COUNCIL ACTION FORM

SUBJECT: MAJOR SITE DEVELOPMENT PLAN AMENDMENT FOR 3505 AND 3515 LINCOLN WAY (WALNUT RIDGE)

Attachment B Major Site Development Plan Amendment Documents

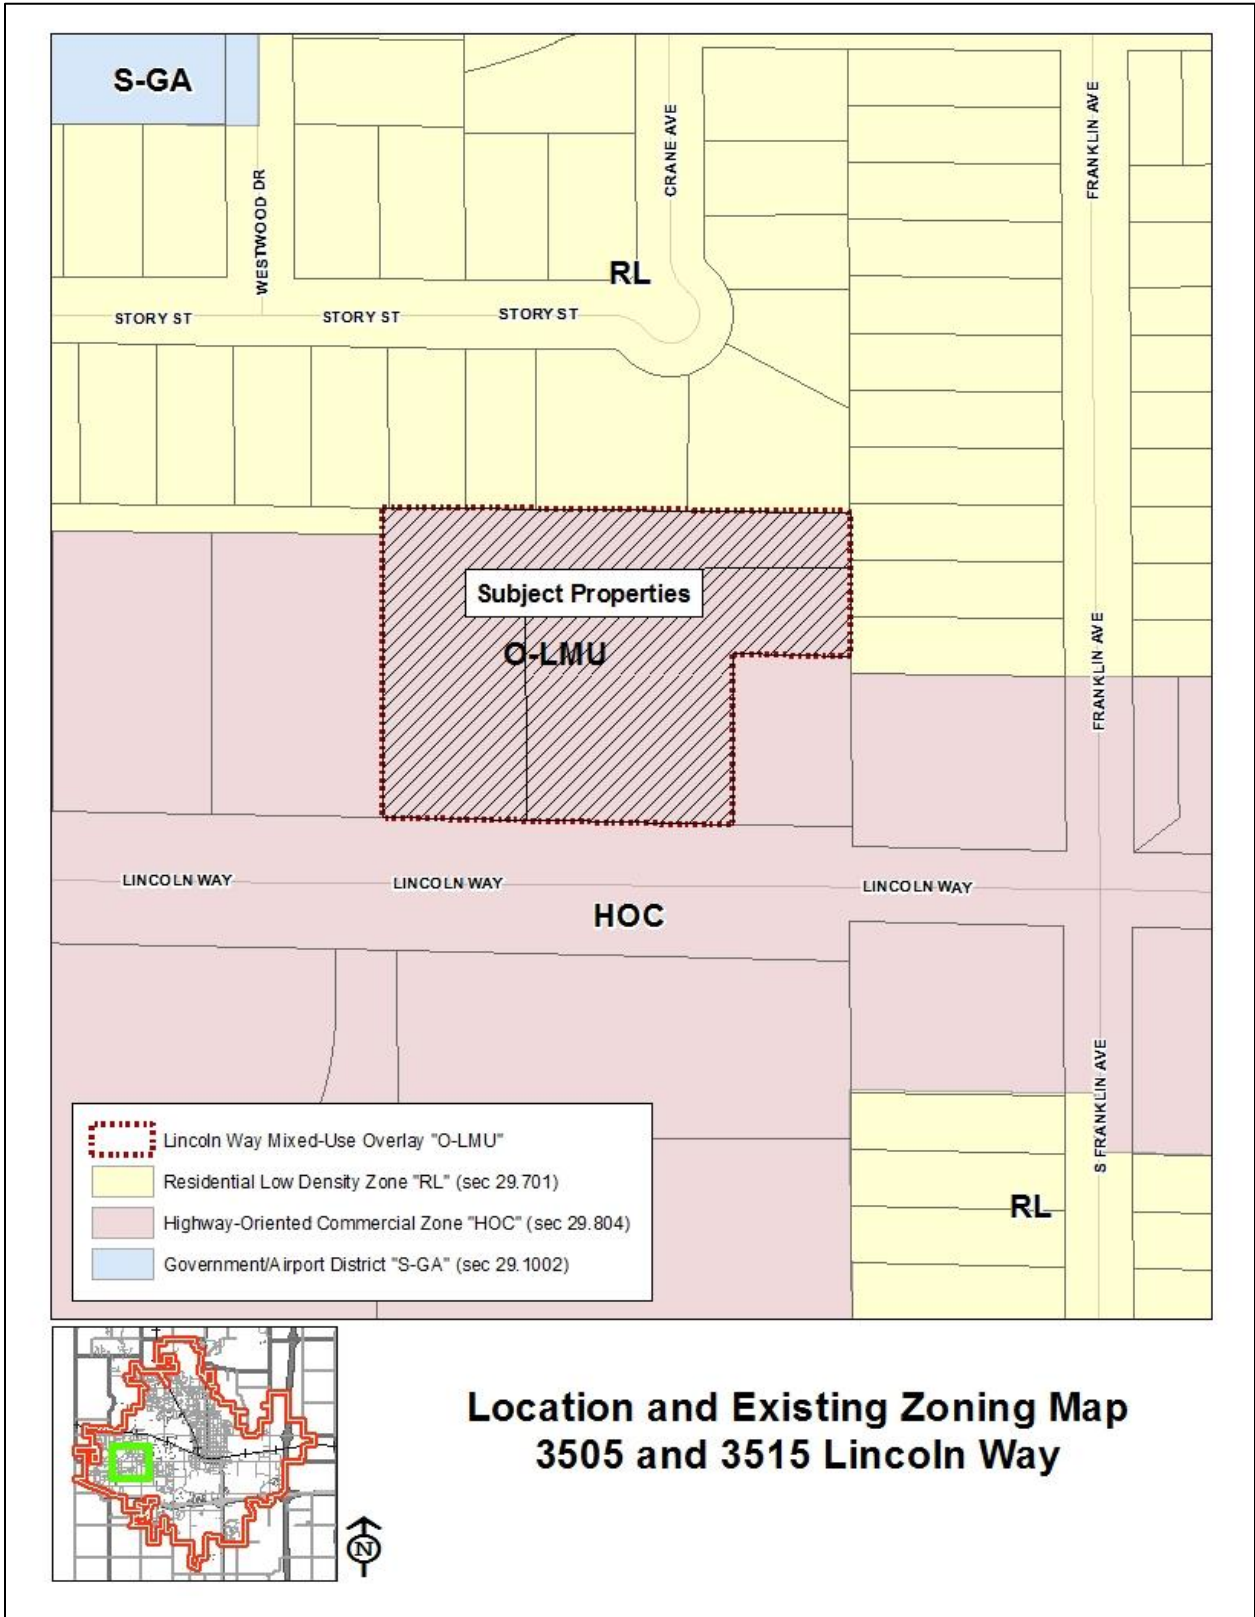
The developer desires to change the L2 screen along the west property line due to the style of the retaining wall that was constructed that limited the depth of soil for plantings and the limited physical space along the property line for plants to grow. The parking lot is located on the low side of the 5-6 foot wall so all visibility of parked vehicles from the neighboring property is obstructed in this area due to the wall. **The developer proposes only ground cover in this area and to plant only one of two required trees due to the retaining wall location.**

The proposed plan includes a revision to the other landscape areas of the site along the north and east property lines to screen the parking lot with the existing 6-foot wood fence and using a mix of grasses and shrubs to meet the intent of the parking lot screen requirements and the use of understory trees. Grasses typically are not counted to meet the minimum screen requirement of an L2 or L3 screen. The east lot line is the most difficult area to address landscaping as the slopes of the detention area limits planting space for such screen requirements. **Lower height crabapple trees have been proposed along the north and east property lines to stay below the overhead power lines, but still meet tree requirement of the ordinance for trees within the screen areas.**

1. The City Council can approve the Major Site Development Plan Amendment for 3505 and 3515 Lincoln Way to allow for the proposed revision to the Landscape Plan with the following condition:
 - A. The developer is responsible for the construction and maintenance of the 6-foot fence along all residential property lines.
